## Very minor basement wall changes

### Basement Walls Comparison

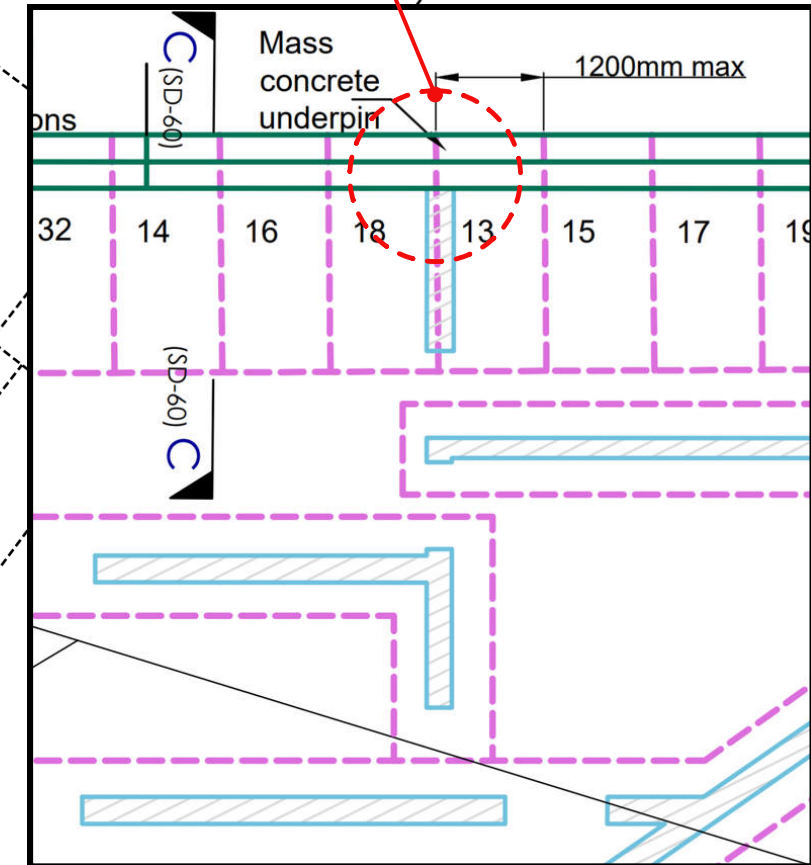
**A.** This wall moved just 600mm

**C.** The basement outer wall is exactly the same as the previous application. To reduce the perceived depth of the light-well, a block-work wall will be added and then the void back-filled.

**B.** This bedroom wall moved 310mm

**D.** These two walls moved to here.

**E.** Two small sections of garden walls moved 300mm
